Re: <u>Agenda Item No. 3: Addendum to Conditional Use Permit No. 10-05</u>
(American Kings Solar, LLC)

These comments are submitted on behalf of Kings County Citizens for Responsible Development ("Citizens") regarding Agenda Item No. 3: Addendum to Conditional Use Permit ("CUP") No. 10-05 (American Kings Solar, LLC) ("Project" or "American Kings Project"). Originally approved as the GWF Henrietta Solar Project in 2010 ("Original Project"), the Original Project proposed the construction and operation of a 125 megawatt ("MW") solar photovoltaic ("PV") facility on 957 acres of land located east of 25th Avenue, south of State Route 198, and west of Avenal Cutoff Road in Lemoore, California. The Original Project was proposed by applicant GWF Energy LLC ("Original Applicant") and approved by Kings County ("County") on

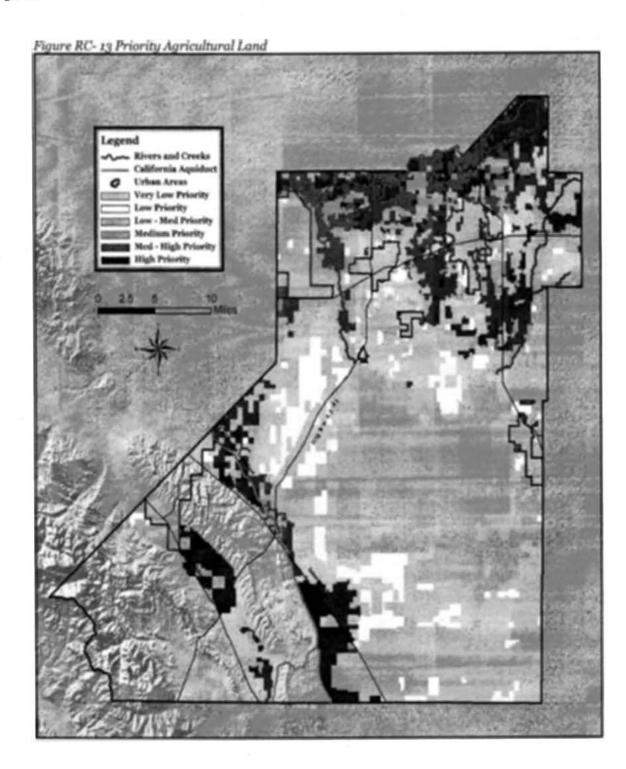
The Staff Report and Addendum fail to discuss Section 1112(B), and fail to state whether the Project site lands are designated as "Very Low Priority," "Low Priority," "Low-Medium Priority," or "Medium Priority" under Figure RC-13 of the General Plan's Resource Conservation Element.³⁴ Buried in Appendix A to the Addendum, the redlined MND states that the Project site is designated as "Medium Priority" pursuant to Figure RC-13.³⁵ This is also apparent from a comparison with Project mapping (see figures below).

Since the Project site is considered "Medium Priority," Development Code Section 1112(B)(2)(a) should require that the Project include "comparable" agricultural operations or provide mitigation for the loss of the "Medium Priority" use. However, this requirement is never discussed.
